17th January 2020

Our ref: GE18103/LL01v2.0/200117
Your ref: LU/354/19/DOC

RE: Land South of Cornfield Close Littlehampton BN17 6LD- Approval of details reserved by condition imposed under ref LU/330/18/PL relating to Condition Nos 9 - periodic verification reports

PARTY WALL/G.F. SLAB SUBSTRUCTURE DETAIL - MASONRY APARTMENTS

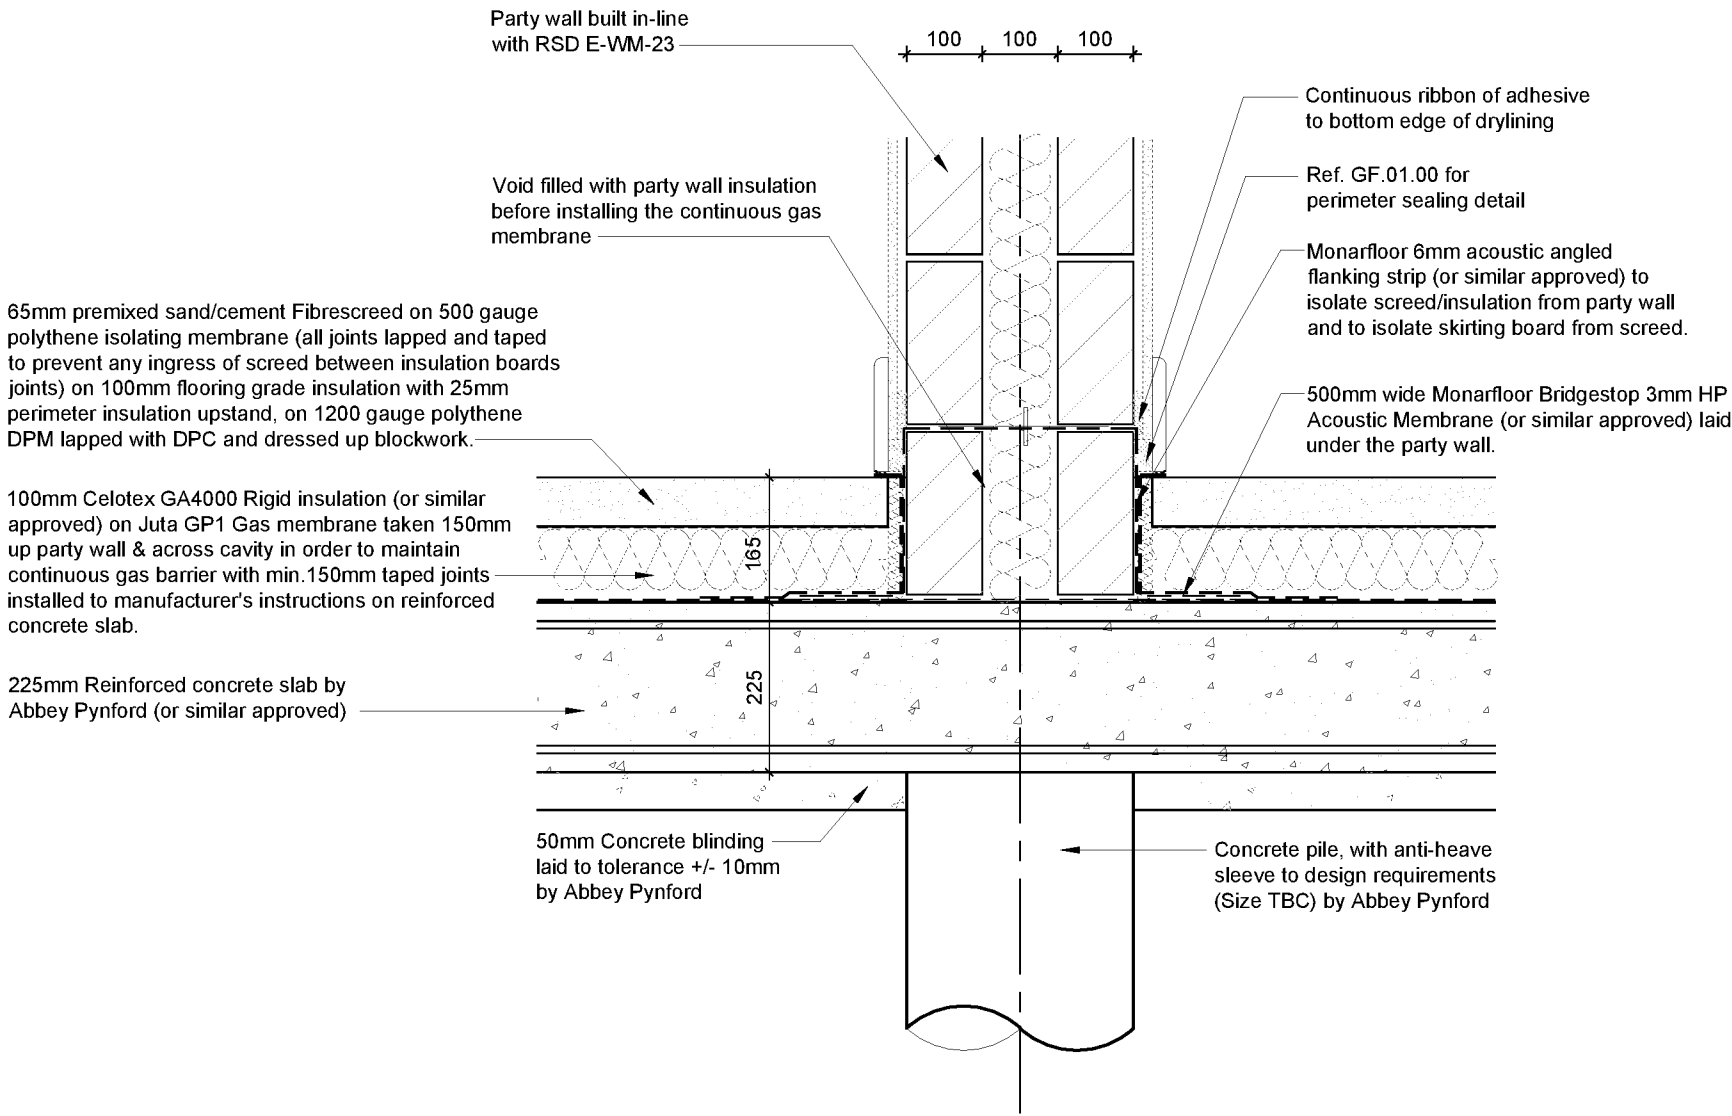
- 2) Furthermore, exceedances of methane, carbon dioxide, oxygen, carbon monoxide, hydrogen sulphate and VOCs were previously identified, however only methane and carbon dioxide concentrations are discussed -this should be clarified.**

We understand that it is proposed to utilise a Juta GP1 membrane as part of the development, GP1 is specifically designed and manufactured to perform as a Methane, Carbon Dioxide, Radon, Ground Gas, VOC, air & Moisture protection system, and therefore will provide a sufficient level of protection to the building and users from the elevated concentrations of gases (Methane and Carbon Dioxide) identified beneath the site.

C03	19.12.19	DETAIL UPDATED TO SUIT GAS MEMBRANE COMMENTS.	AJH	CD		
C02	09.10.19	SUB FLOOR VOID & VENTS OMITTED & DPC'S UPDATED.	AJH	CD		
C01	12.06.19	ISSUED FOR CONSTRUCTION	AJH	CD		
P02	07.03.19	225mm AIR VOID AND TELESCOPIC VENTS INTRODUCED.	AJH	CD		
P01	07.12.18	FIRST ISSUE	AJH	CD		
REV	DATE	DESCRIPTION	INITIAL	CHECKED
